DEV2017/864  
2 May 2018

### **CARSELDINE URBAN VILLAGE - STAGE S RESPONSE TO FURTHER ISSUES - TRAFFIC MATTERS**

CARSELDINE URBAN VILLAGE -  
STAGE S

Figure 1-4 Fitzgibbon Development Scheme

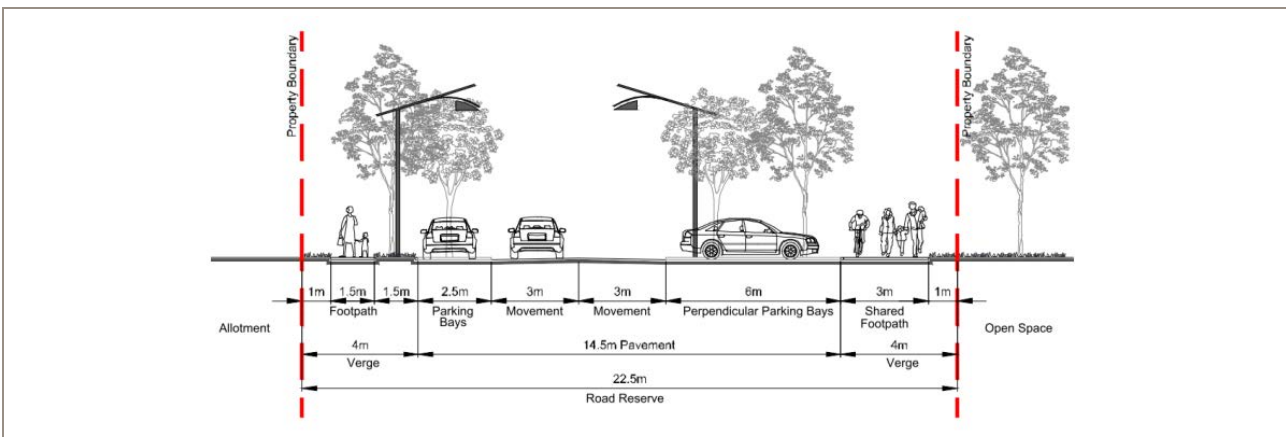
The east-west road adjoining the park is classified as a Residential Park Esplanade in the Fitzgibbon Development Scheme. The Development Scheme identifies the road reserve width as 21m however the cross section indicates that the road components add up to 22.5m. This is illustrated on Figure 1-4.

The Cardno TIA presented the cross sections prepared by RPS. This proposed a generally consistent cross section with that outlined in the Development Scheme, however with a slight change to the multi-use/shared path width from 4m to 3m with a 1m landscaped strip. Overall, the road reserve width (22.5m) is consistent with the Development Scheme. The proposed cross section is outlined in Figure 1-5.

The deviation from the Development Scheme is considered to be minor and consistent with the intent of the proposed road corridor. The provision of a 3.0m wide shared path is consistent with Austroads guidance for path widths, which indicates a range of 3.0m to 4.0m for recreational paths.

Figure 1-6 Comparison of On-street Parking Design

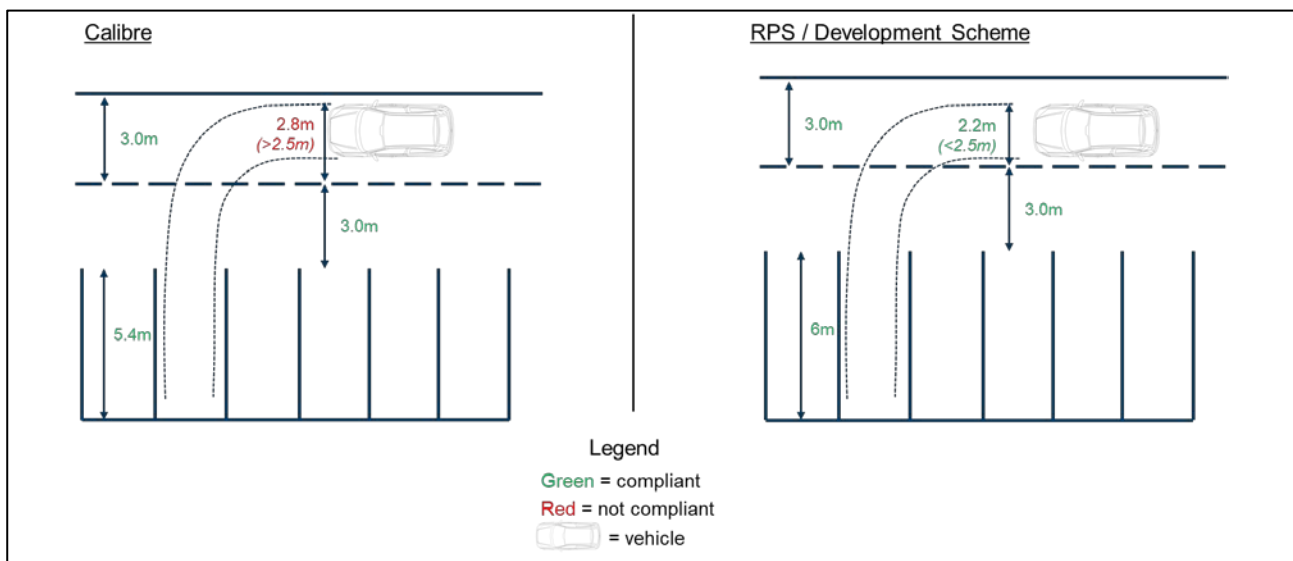
Confirm proposed road designs are compliant with the design standards contained in the Fitzgibbon Development Scheme; Cardno TIA and the Calibre Engineering Services Report indicate different functional layouts for the east-west road adjoining the park. Please ensure all technical reports are consistent and show the same layouts.

- > Perpendicular on street parking is 5.4m long instead of 6.0m, as presented in the Development Scheme and the RPS proposed cross section. However, it is noted that this is in accordance with the Australian Standard AS2890.5 for on-street parking facilities which stipulates that a minimum of 5.4m space length is required.
- > Shared use path is 3m wide, consistent with the RPS proposed cross sections but not consistent with the Development Scheme (4m).

The Calibre design allows for 5.8m manoeuvring space as per the standard, however this requires encroachment of 2.8m into the adjacent travel lane which is greater than the allowable 2.5m.

The RPS and Development Scheme designs provides an additional 0.6m manoeuvring space with the provision of 6m long bays, allowing for 2.2m encroachment into the adjacent lane, which is in accordance with AS2890.5. However, it is noted that the additional 600mm length provided within the bays should be allocated as road space to avoid the situation where vehicles park up to the edge of the space, minimising the manoeuvring space possible for other vehicles.

Therefore, Cardno recommends the following amendments be made to the final design of the road:

- > space length of 5.4m
- > 3.6m travel lane width for lane immediately adjacent to parking, this is an increase of 0.6m from the Development Scheme, RPS and Calibre designs.

<b>Carseldine Urban Village</b>			
Safe Intersection Sight Distance Review			
Proposed Stage S Access Intersection			
50km/hr Design Speed			
Drawn	Date	Scale	Size
T.Anang	08/02/2017	1:500	A3
Drawing Number			Revision
CEB06857 - SK13			A

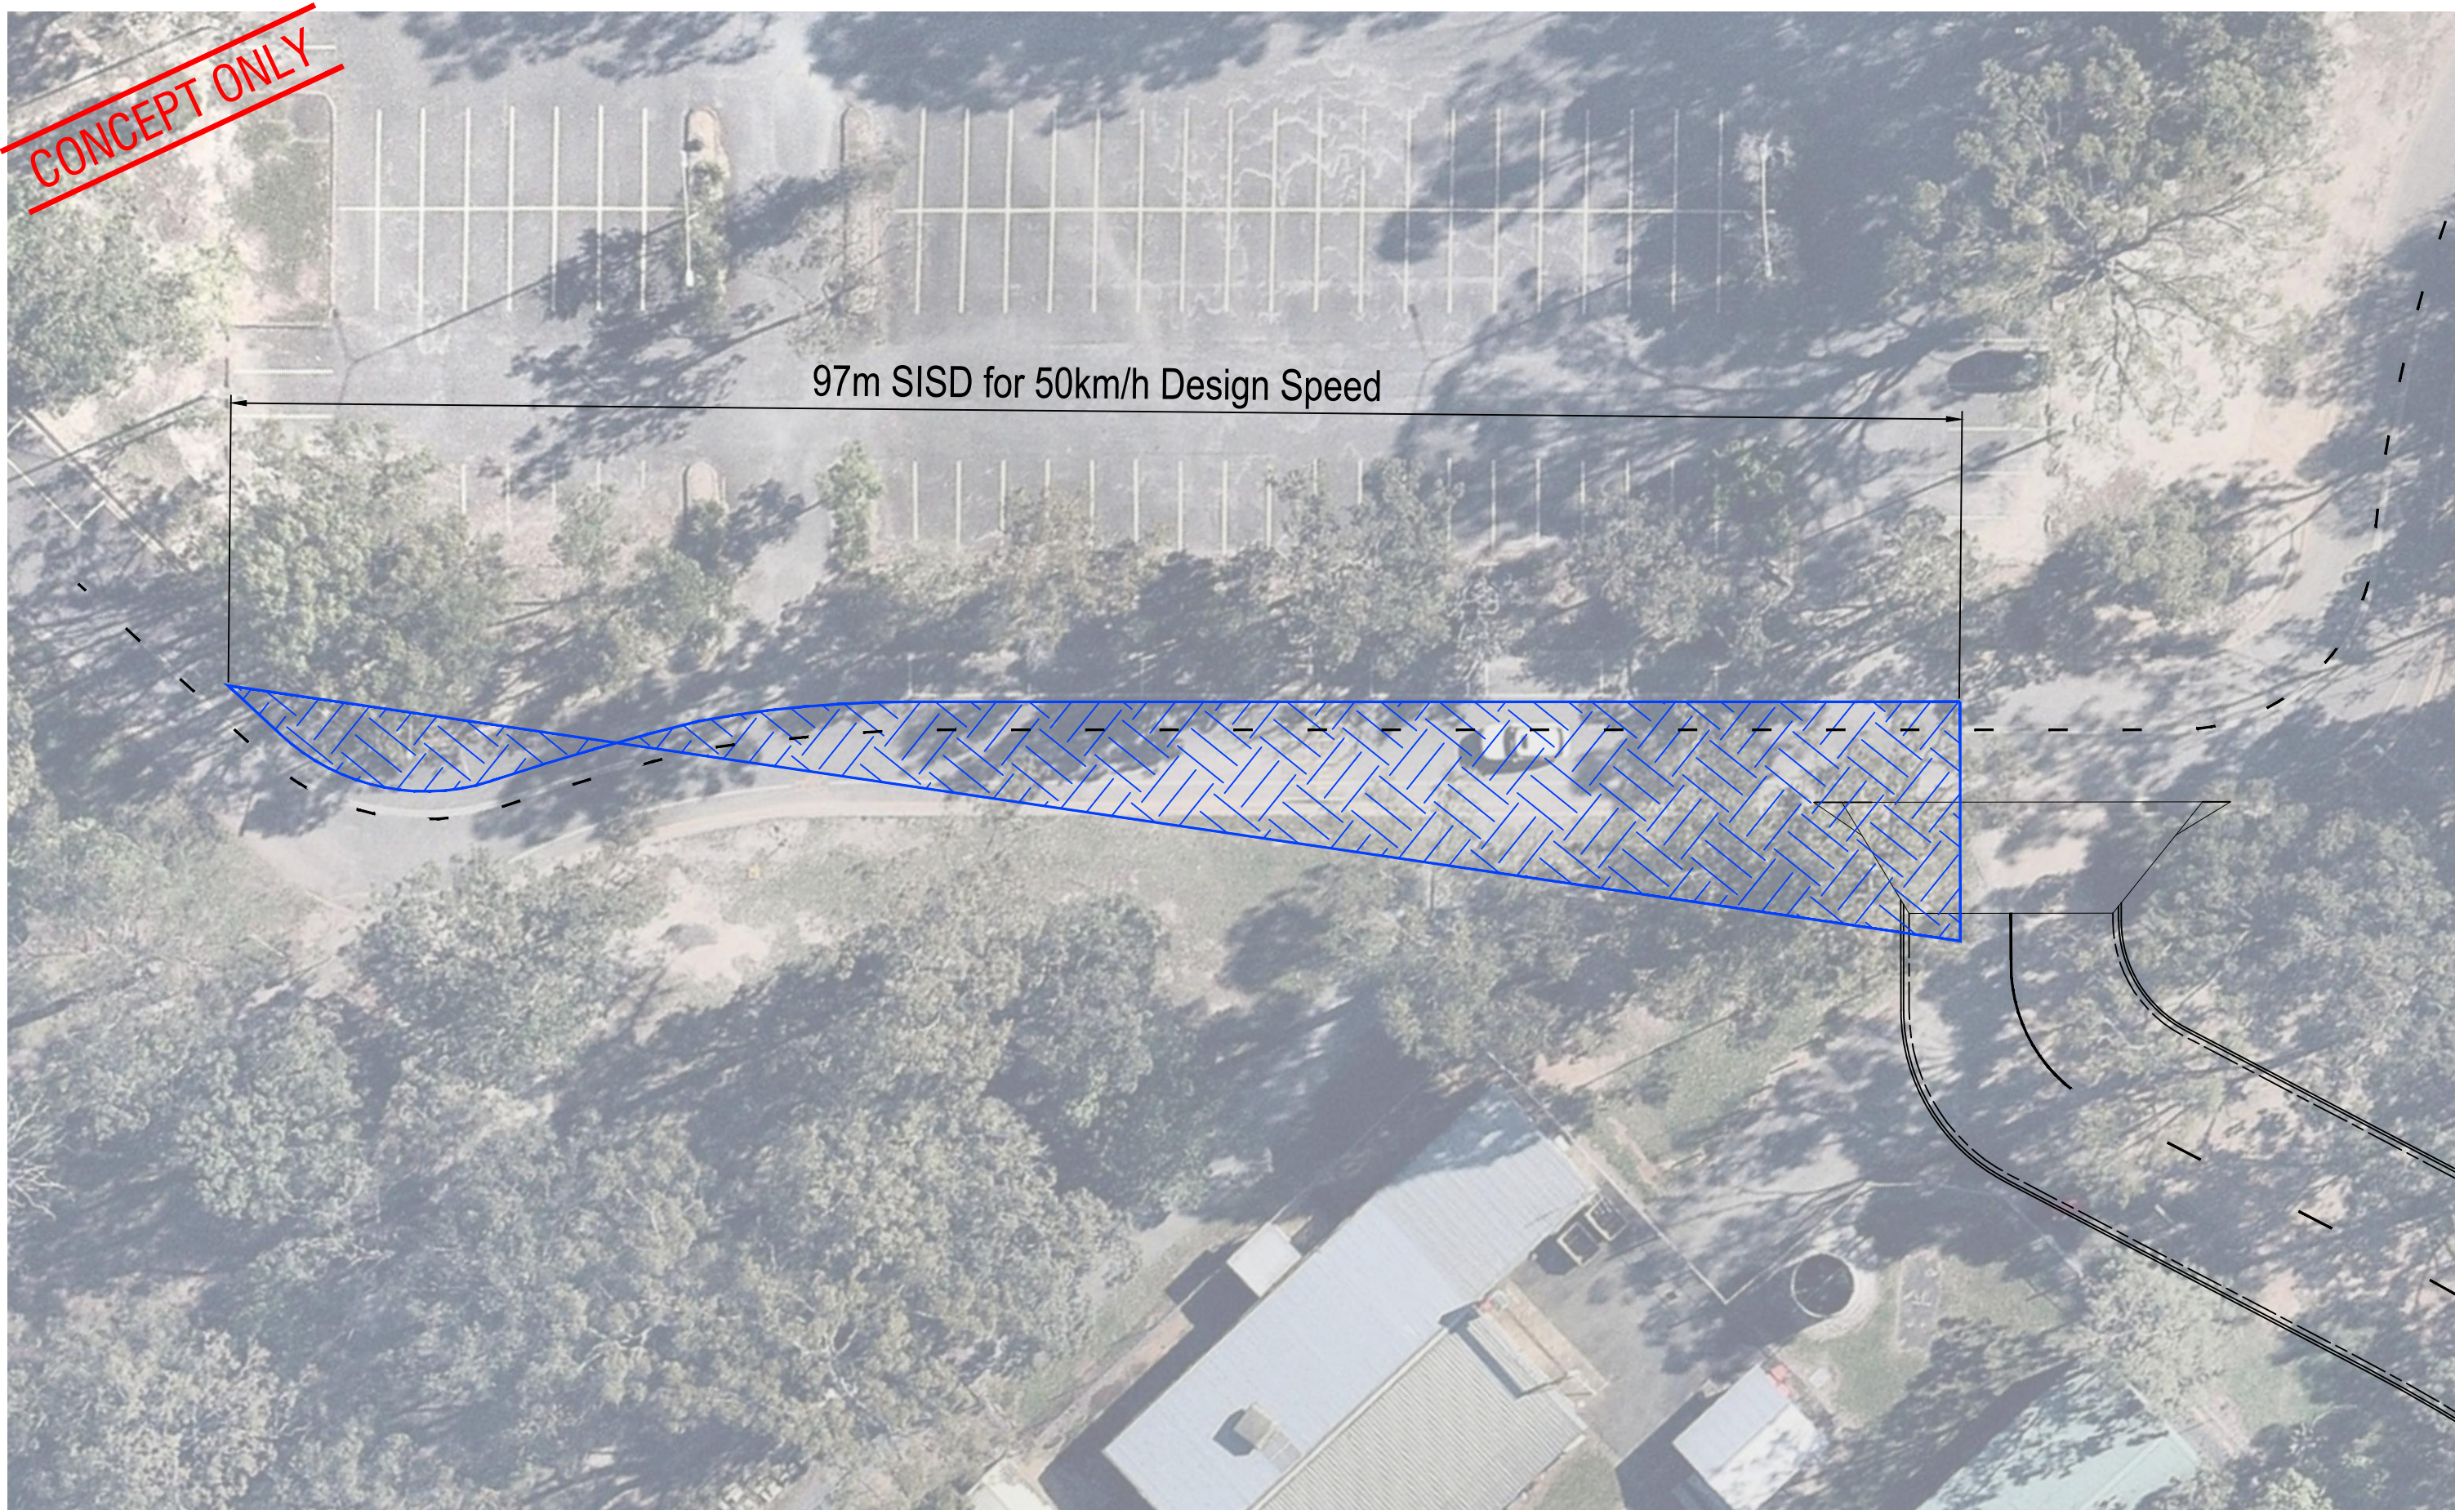
*Safe Intersection Sight Distance*

In terms of the safe intersection sight distance (SISD) from the minor road, the values outlined in Austroads Guide to Road Design Part 4A Table 3.2 were referred to. The site specific parameters adopted include the following:

Based on these parameters, it is determined that the safe intersection sight distance is 97m.

The sight distance drawings CEB06857-SK12-A and CEB06857-SK13-A demonstrate that sufficient sight distance (in excess of 97m) is provided at the proposed temporary access. Similar to Figure 1-2, vegetation maintenance is required for the overgrown bushes on the eastern verge of the road to maintain clear sight lines.

<b>Carseldine Urban Village</b>			
Minimum Gap Sight Distance Review			
Proposed Stage S Access Intersection			
50km/hr Design Speed			
Drawn	Date	Scale	Size
T.Anang	08/02/2017	1:200	A3
Drawing Number			Revision
CEB06857 - SK14			A

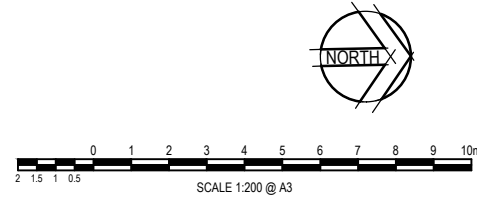
*Demonstrate how the temporary access road has adequate sight lines for a right turn movement from the existing internal road to the new temporary road.*

Based on these parameters, it is determined that the minimum gap sight distance is 55m.

The sight distance drawing CEB06857-SK14-A enclosed demonstrates that sufficient sight distance (in excess of 55m) is provided for right turning vehicles turning into the proposed temporary access. Some vegetation maintenance is required for the overgrown bushes on the eastern verge of the road to maintain clear sight lines, as illustrated on Figure 1-2.
